PREDETERMINATION SETTLEMENT AGREEMENT

CP# 11-17-71269
HUD# 07-18-8027-8

PRAIRIE RAPIDS, L.L.C.
211 1st Avenue SE, Suite A
Cedar Rapids, Iowa 52401-1114

PAVEMENT MARKING NOTES:

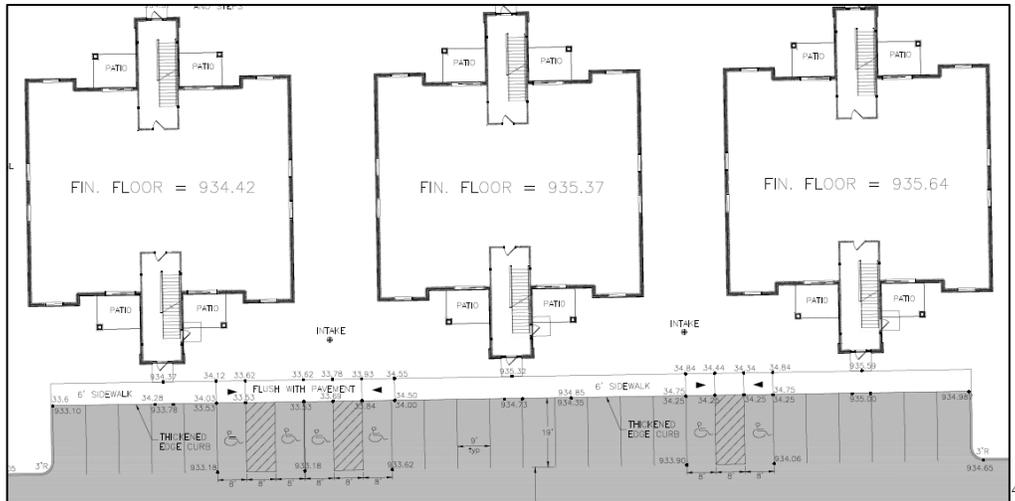
- 1) Although no instructions were found for the installation of signage designating spaces as reserved for persons with disabilities, the plans submitted by Respondents includes notes and diagrams, which indicated a requirement for paint markings to designate these spaces. The relevant instructions and plan diagrams are shown below.

Based on these instructions and diagrams, paint stripes defining the width of these parking spaces were required. If the marking stripes would have been painted according to the instructions and diagrams referenced above, the width of these parking spaces could have been defined and would have been compliant with the width requirements from ANSI 1986, 2003, and 2009, and the marking requirements from ANSI 2003 and 2009. However, the required markings were observed to be absent during both the testing and the inspection of Prairie Rapids. Finally, as built, the required signage designating spaces as reserved for persons with disabilities is missing. The lack of signage and markings allows persons without disabilities to legally park both in front of and to either side of the curb ramps, which prevents persons with disabilities from parking as close as possible to the accessible curb ramps.

- 1) ICRC concurs with Respondents' proposal to install parking paint stripes and signage in compliance with Sections 4.6 and 4.28 from ANSI 1986. ICRC will require that this modification be completed within 60 days of the date of the Closing Letter from ICRC.

- (a) The parties agree that the parking area adjacent to Buildings 130, 140, and 150 lack the required paint strip markings and signage required by ANSI 1986 to allow identification of the parking spaces and access aisles.
- (b) Respondents agree they will install the required paint stripe markings and signage to identify at least one access aisle and parking space adjacent to the curb ramps located near Buildings 130, 140, and 150, and in compliance with all requirements – including the minimum dimensional requirements – specified in Sections 4.6 and 4.28 from ANSI 1986, which is available online at: <http://cdn.loc.gov/service/ll/fedreg/fr055/fr055116/fr055116.pdf>.¹²
- (c) Respondents agree to complete the retrofits described in the current section within 60 days from the date of the Closing Letter from ICRC.

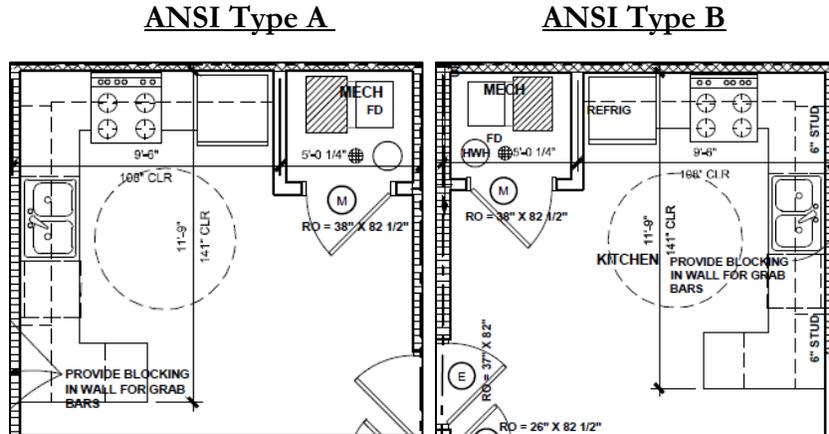
5) The plans submitted by Respondents include scaled drawings of the dwelling units. The relevant portions of the drawings for an ANSI Type A unit and an ANSI Type B unit are shown below:⁹

Based on the scaled drawings above, the midline of the range was designed to be about 20" away from the adjacent opposing countertop. In all inspected units, the midline of the range was measured to be 20 1/4" away from the opposing countertop, which is less than the 24"-minimum required for a parallel approach by someone using a wheelchair.¹⁰ As designed and built, the kitchens in all inspected units are unusable because the midlines of the ranges are too close to the opposing countertops to allow tenants using wheelchairs to make the required parallel approach.

5) Respondents will adjust kitchen counters and cabinets, and relocate the ranges to allow a 30" x 48" minimum clear floor space centered on range to increase the clearance from center of range to nearest obstruction to the 24"-minimum and allow the required parallel approach by someone in a wheelchair.

- 5) ICRC concurs with Respondents' proposal to modify kitchen counters and cabinets, and relocate the ranges to allow a 30" x 48" minimum clear floor space centered on range to increase the clearance from center of range to nearest obstruction to the 24"-minimum and allow the required parallel approach by someone in a wheelchair. ICRC will require that this modification be completed within one year of the date of the Closing Letter from ICRC or sooner if requested by a tenant with a disability.

(b) Respondents agree they will modify the kitchen base cabinets and counters adjacent to the range at all ground-floor units in Buildings 130, 140, and 150, and then move the range further away from the nearest obstruction to increase the distance from the midline of the range to the nearest obstruction to no less than the 24"-minimum required in the Manual.
